Technical Bulletin

Bulletin Number: 327 Revision Number: R-02

SUBJECT: END CAP, TRIM

MODELS AFFECTED: DNCB 180CC (Landscape) Venders
All DNCB Seven-Up B7 Venders

Side View of
Both Parts

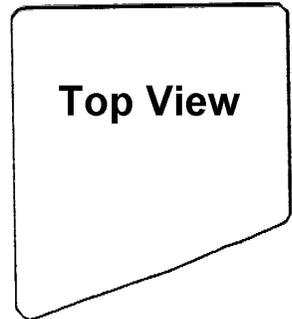
REASON: To close the end caps for cosmetic purposes.

Install sealant in top of trim to prevent water from entering and to improve the cosmetic appearance of the trim.

For a short period of time beginning 0001-6093CQ Trim Caps were used. This was discontinued due to cosmetic problems.

ORDER: 903,600,48x.x1 Black Sealant

Usage: For Coca-Cola 180CC Landscape Venders use one (1) each of 801,807,09x.x1 (OBSOLETE) and 801,807,08x.x1 (OBSOLETE).
For all 7UP B7 Venders use one (1) of 801,807,08x.x1 (OBSOLETE).
